**Re: 51 Arthur Street, Forestville  
Fire Engineering Development Application Advice**

We have perused the provided architectural general arrangement plans reference A089 dated 9 September 2020 and BCA report by BCA Logic dated 17 September 2020 and provide the following fire engineering advice for the development.

Figure 1 Residential extended egress distance and fire hydrant coverage

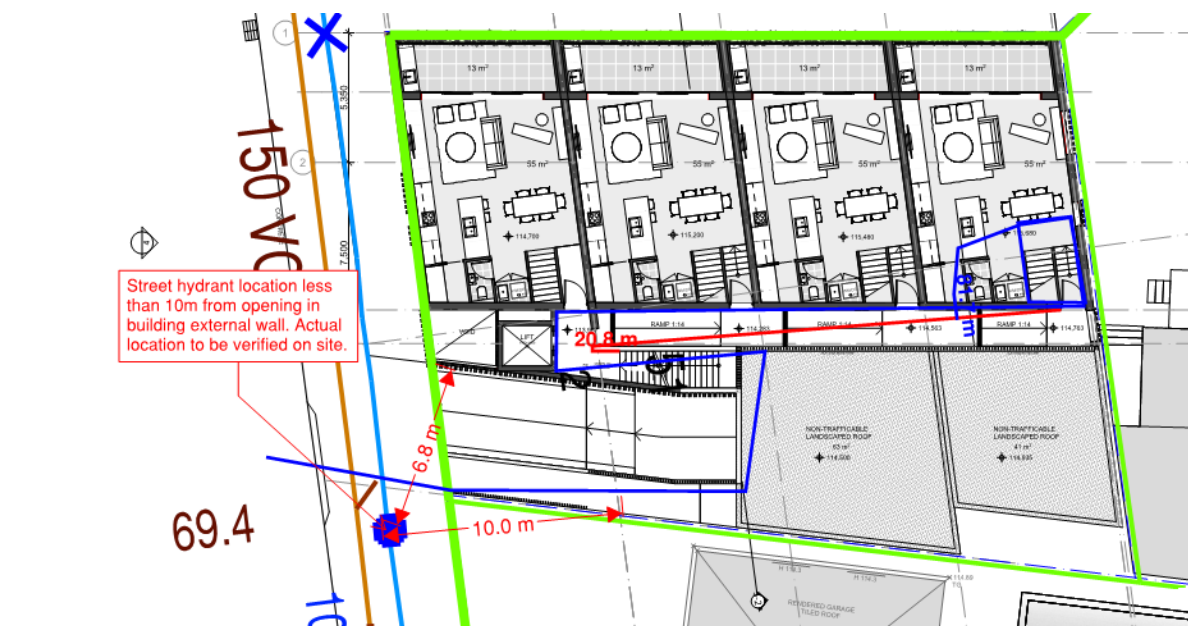
2.	D1.2(c)	Permit single exit from the basement in lieu of two exits.	DP4, EP2.2
3.	D1.4, Spec E1.5a clause 3(b)(iii)	Permit distance to the exit from farthest residential SOU to be 21 m in lieu of 12m. Refer Figure 1.	DP4, EP2.2

4.	E1.3	Permit hydrant coverage from street hydrant less than 10m from the building, using three lengths of hose in lieu of two lengths of hose. Distance to 1m inside furthest room is approximately 70m from fire brigade hardstand.	EP1.3
